THE NAPA COUNTY REGIONAL PARK AND OPEN SPACE DISTRICT Camp Berryessa Improvement Project

ADDENDUM No. 2

Issued: September 2, 2014
REVISED Bid Date: **Monday, October 6, 2014 1:00 pm**

Camp Berryessa Improvement Project

G00.03

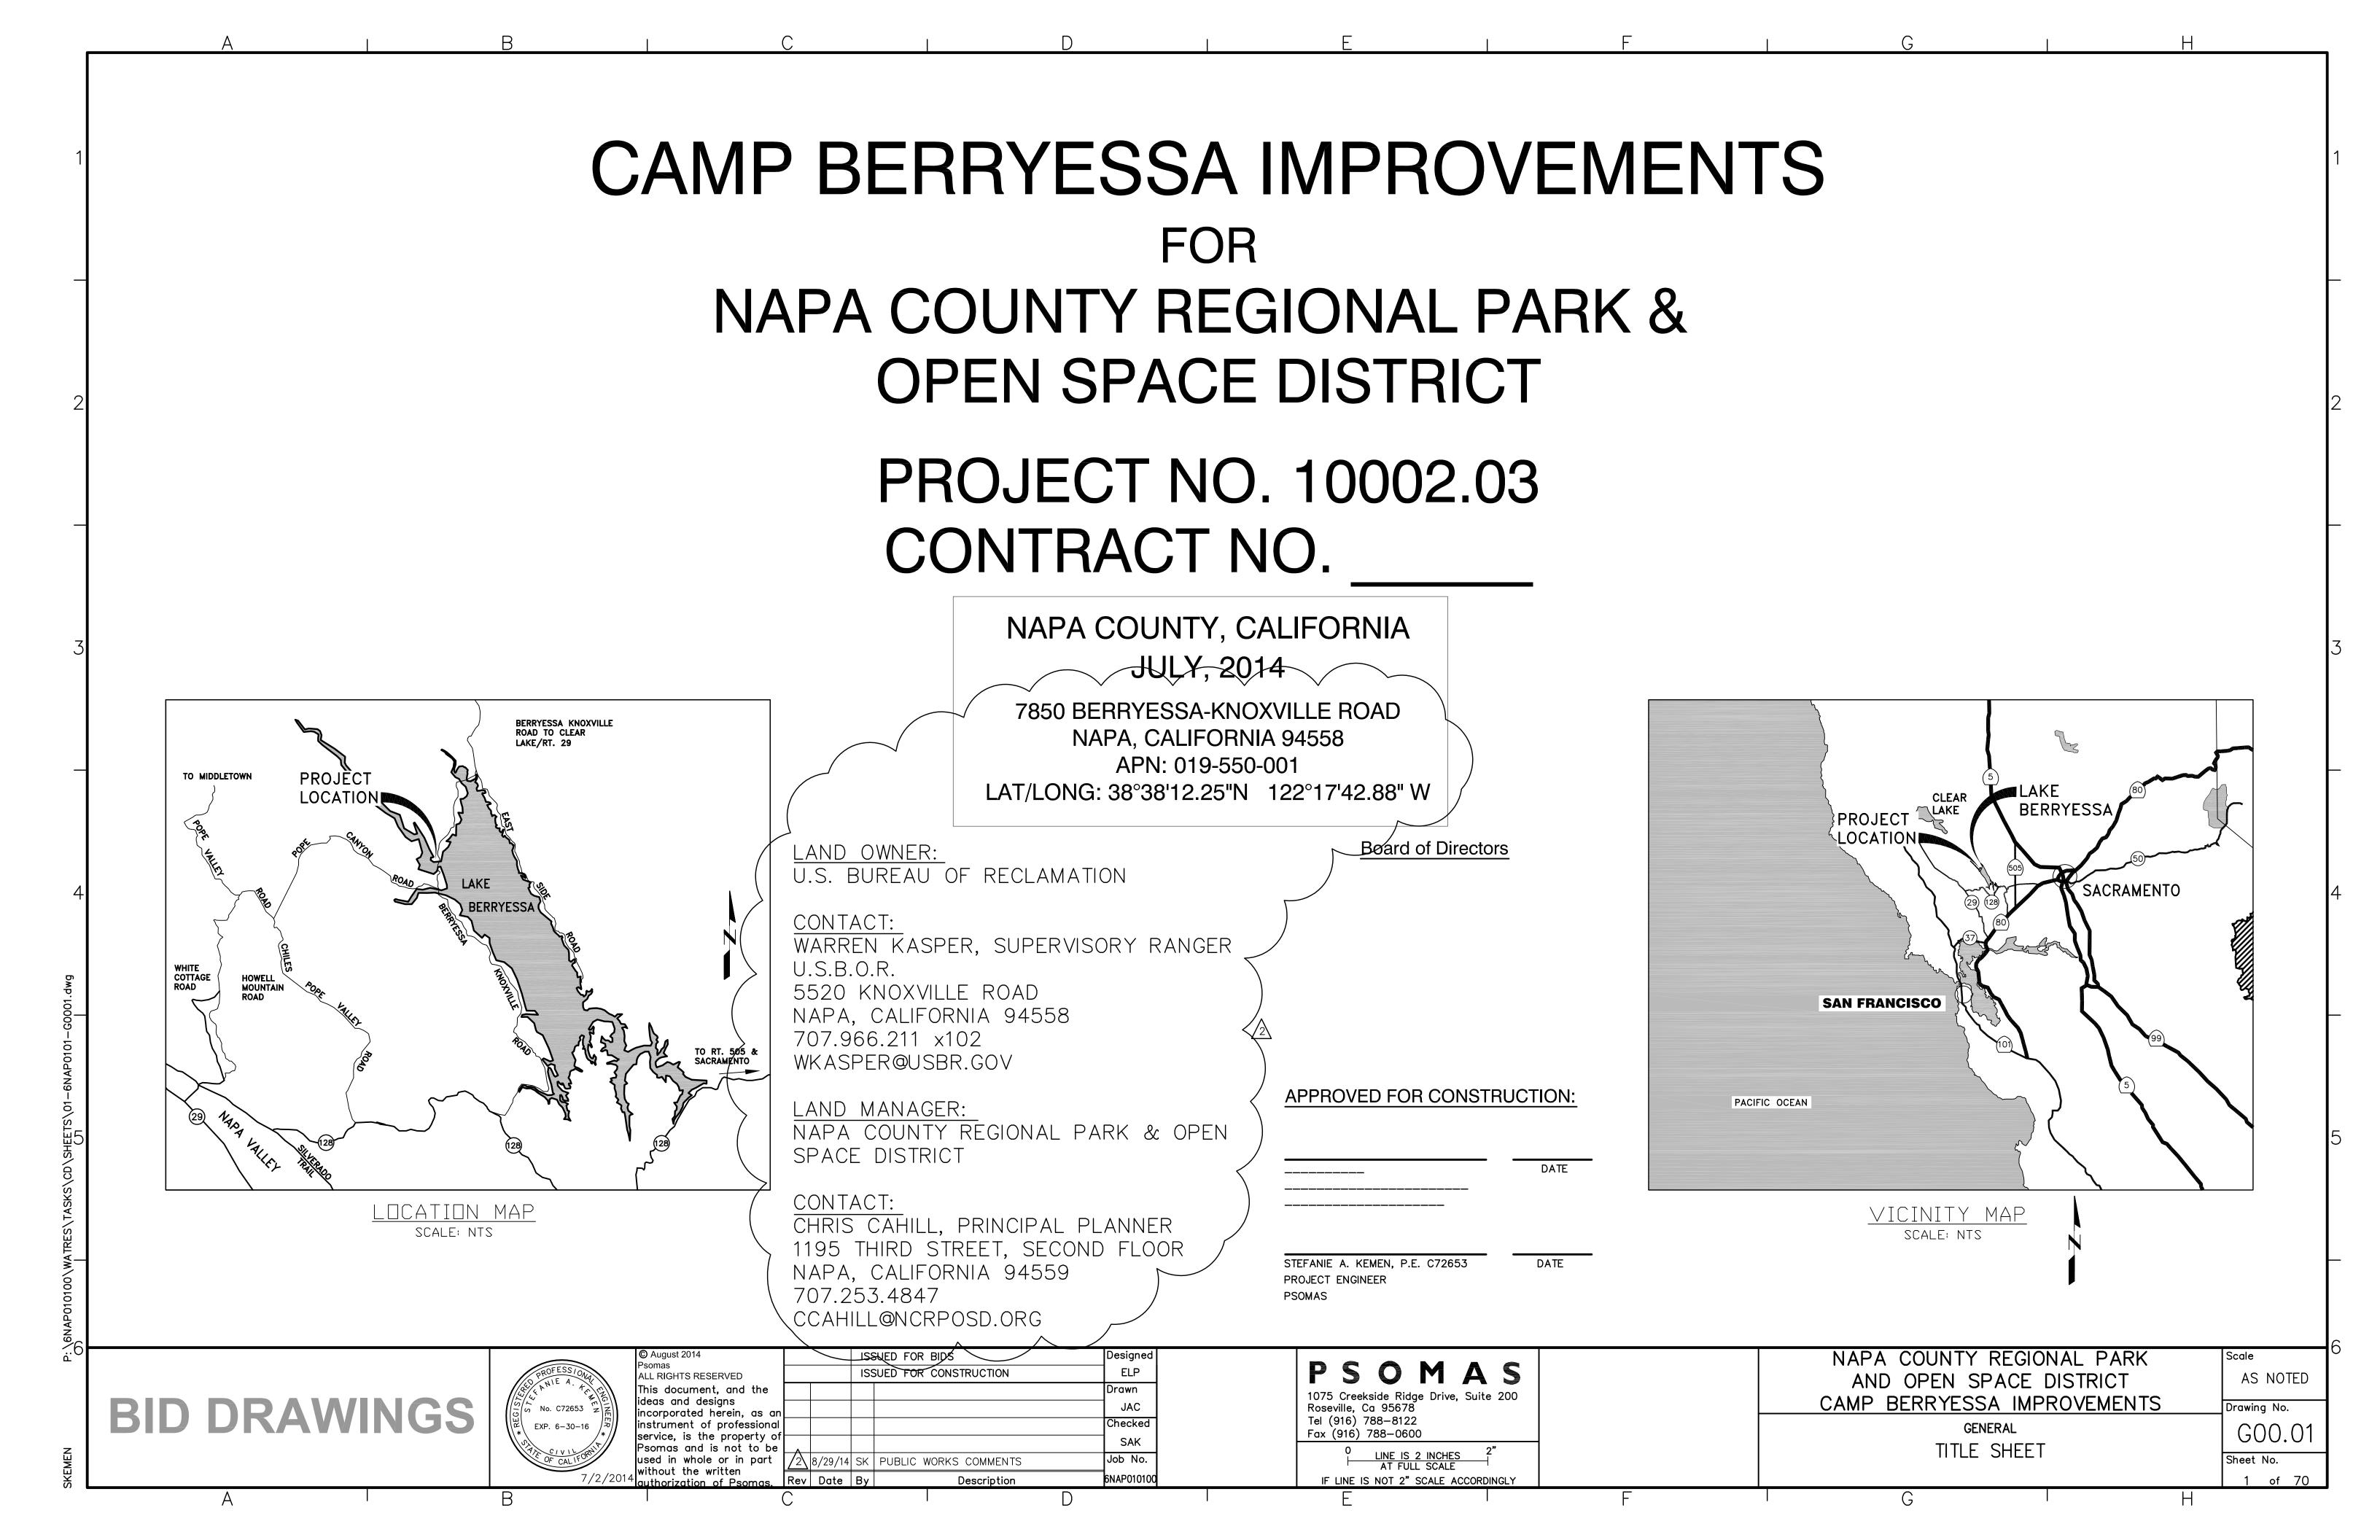
ISSUED FOR BIDS ELL ISSUED FOR CONSTRUCTION Drawn Checked service, is the property of 2 8/29/14 SK NOTES REFLECT CURRENT CODES & COUNT SAK Job No. FIRE DIVISION COMMENTS without the written 7/2/2014 authorization of Psomas. 6NAP01010 Rev Date By Description

- FIRE EXTINGUISHERS SHALL BE INSTALLED AT EVERY TENT CABIN, ACTIVITY SHELTER, AND COMBO BUILDING. (1) 2A10BC AND (1) WATER EXTINGUISHER EACH, ALL INSTALLED IN PROTECTIVE CABINETS.
- PROVIDE 100' DEFENSIBLE SPACE TO ALL BUILDINGS,

AND 10' BOTH SIDES OF ALL ROADS.
